CERTIFICATE OF APPROPRIATENESS PLACARD

[After-the-fact] Changes to a previously approved COA-0014-2019, including: Replace all existing basement windows; alter rear window opening; alter roof forms and coverings of front and side porches and rear addition; construct rear covered entry

Andrews-Duncan House

Summary of Work- Certificate of Appropriateness Major Works application, *Revised for Minor Works 5 April 2021*

EXISTING SOFFIT DETAIL TO MATCH

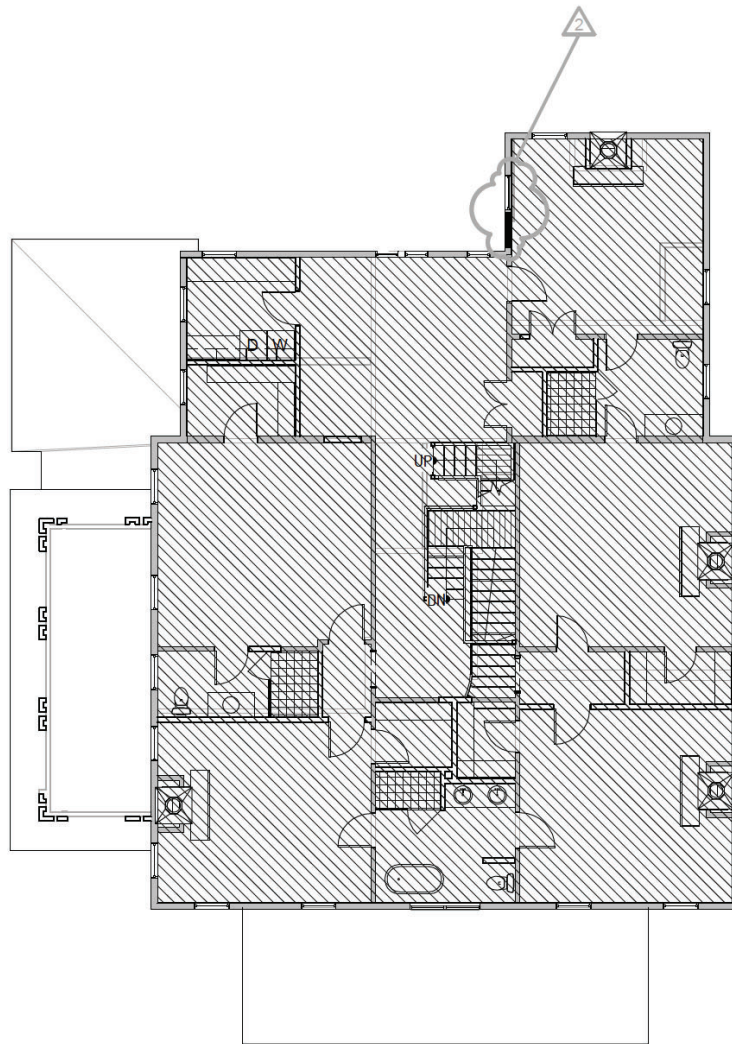
The existing roofs had so many layers built up it was difficult to tell if they were originally flat or low slope. The best case to try and get the built-in gutter system to work is to do the EPDM membrane on all roofs and rebuild the gutter system to look as it was but actually function.

NEW CEILING JOIST/SOFFIT FRAMING UNDER CONSTRUCTION AT REAR UPPER ADDITION, TYP. AT ALL EPDM ROOFS

407 N. BLOUNT STREET WEST ELEVATION
SCALE: 1/8" = 1'-0"

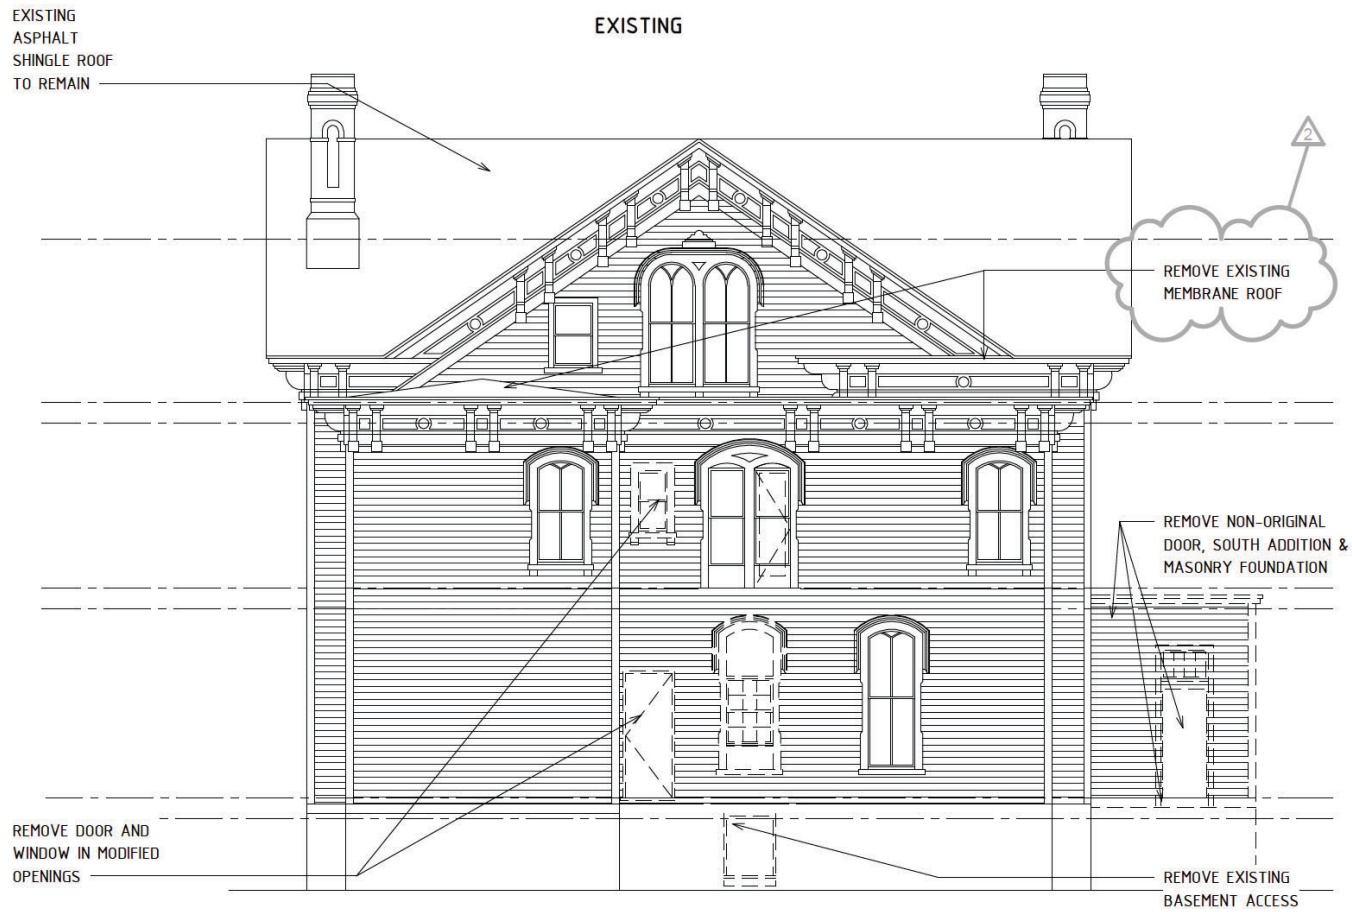
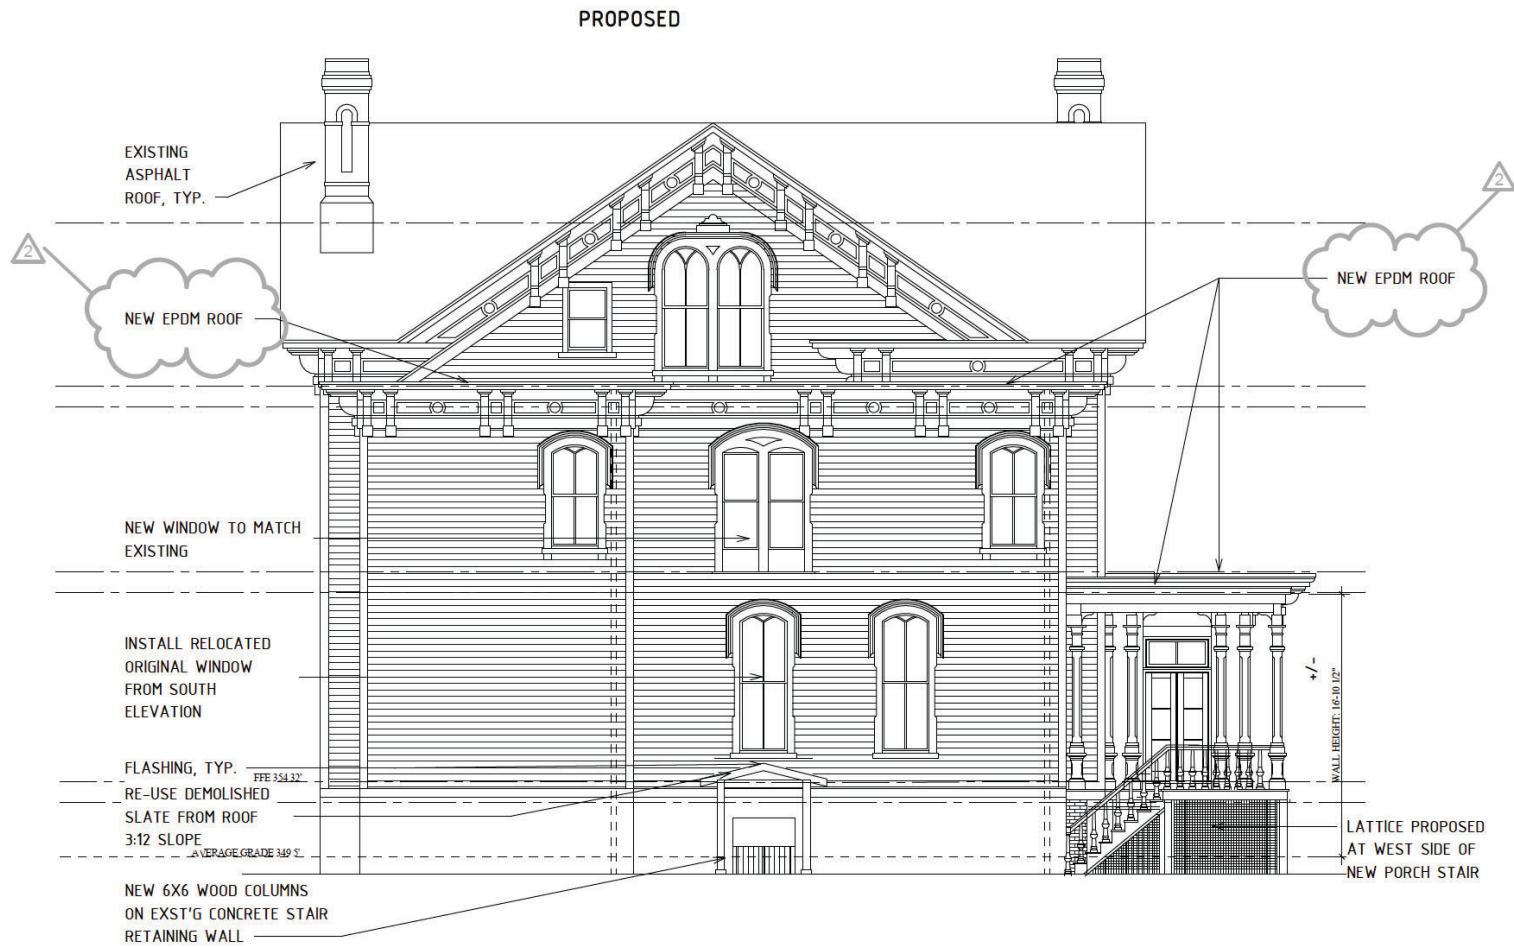
The Major Works application for COA-0014-2019 dated March 2019 has been revised and shown as Revision 2 on the drawings. Revision 2 includes: EPDM membrane roof instead of previous approved metal roof at all low slope roofs, re-used slate roof at lower level basement entry, relocating an existing window to its original location on the North Elevation 2nd level, and replacing all basement wood windows with new windows to match. All revisions are italicized and bold below:

ANDREWS DUNCAN
HOUSE- BASEMENT
PHOTOS

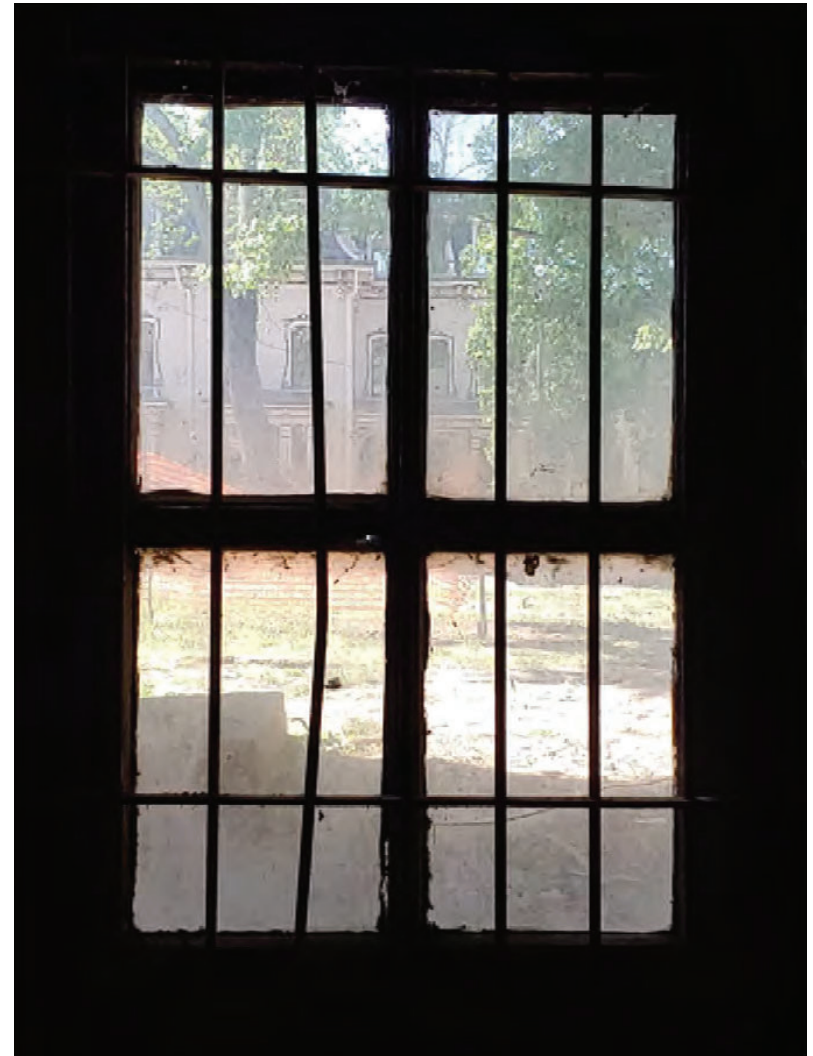
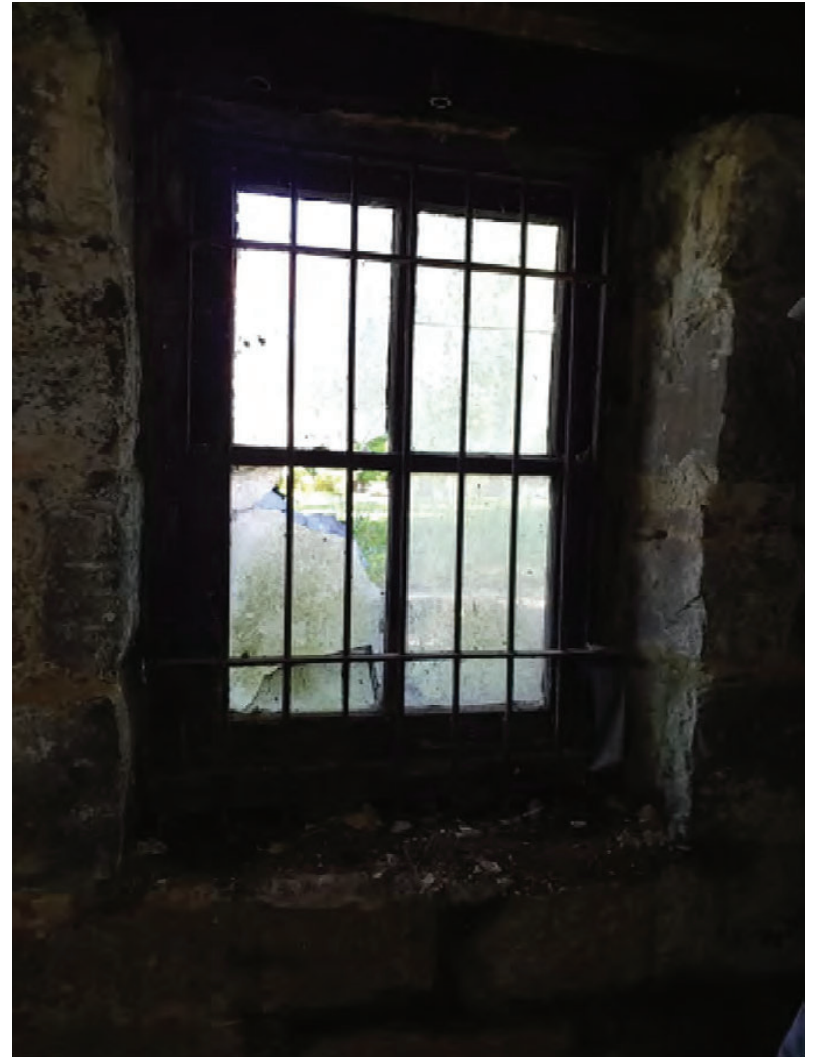
2.7.4 All existing original windows and door are to be repaired. Any new window will match the existing in design, dimension, material and quality of material. ***All basement level windows are deteriorated beyond repair and need to be replaced with new wood windows to match. (Rev. 2)***

Attached are more photos and evidence of the window deterioration at the basement windows. It may be helpful to meet on site if that is an option for you to do. There are so many moving parts and pieces to this project, including the fact that it is still under Ownership by the state and all the work they are currently doing does not have to be approved by RHDC. I am hopeful these items will be quickly approved so they can continue work. They are custom making each window to match.
